City of El Paso – City Plan Commission Staff Report

Case No: SUSU14-00074 – Vista Del Prado Unit Three Replat A
Application Type: Resubdivision Combination
CPC Hearing Date: August 28, 2014
Staff Planner: Nelson Ortiz, (915) 212-1606, ortiznx@elpasotexas.gov
Location: South of Americas and West of Alameda
Acreage: 1.0205 acres
Rep District: 6
Existing Use: Single-family dwellings
Existing Zoning: R-4/sc / R-3/sc (Residential / special contract)
Proposed Zoning: R-4/sc / R-3/sc (Residential / special contract)
Nearest Park: Caribe Park (.28 mile)
Nearest School: Hueco Elementary School (1.6 miles)
Park Fees Required: N/A
Impact Fee Area: N/A
Property Owner: Juana Contreras, Anabel Salazar and Francisco and Luz Arrieta
Applicant: Juana Contreras, Anabel Salazar and Francisco and Luz Arrieta
Representative: CAD Consulting Company

VISTA DEL PRADO #3 REPLAT A

ATTACHMENT 4

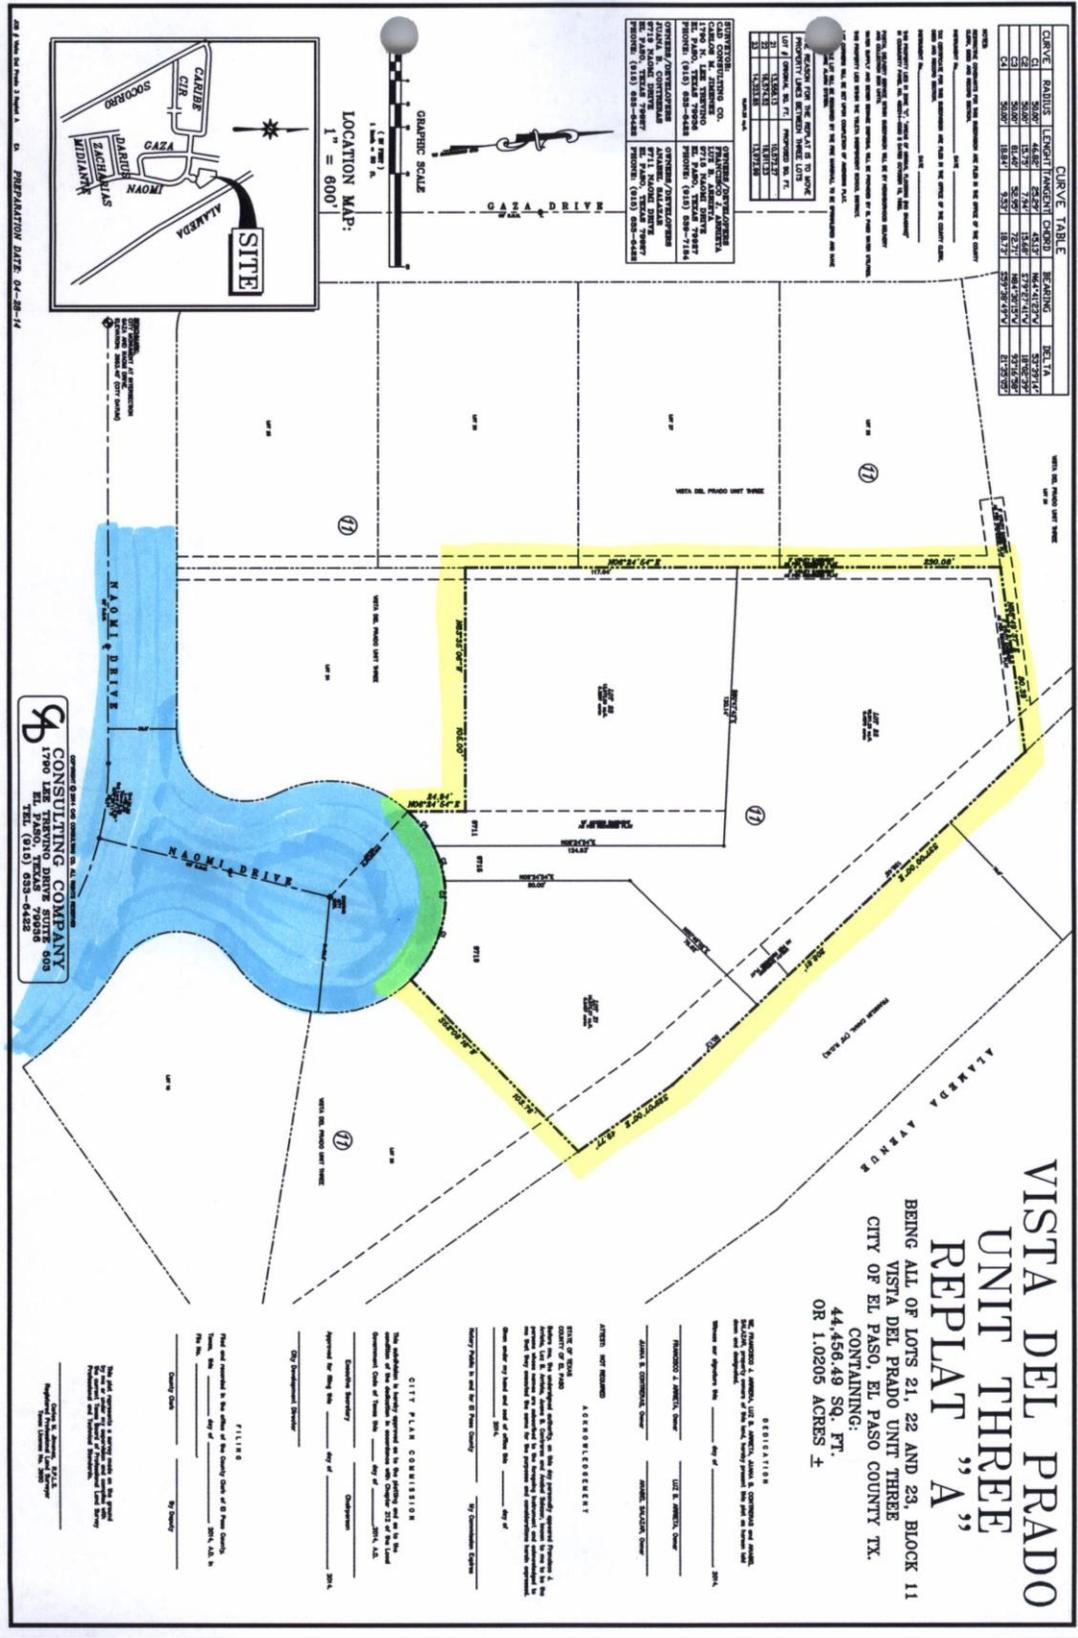
1. Include a note stating that the stormwater runoff was originally designed to be on-site ponding, any future improvements done to the subdivision will have to retain the stormwater runoff.
2. Correct cross Section A-A, area shows concrete header, and not curb and gutter; also include slope percentage.
3. Add note on final plat: Fifty (50) percent of lot area shall remain unimproved with pervious surfaces.
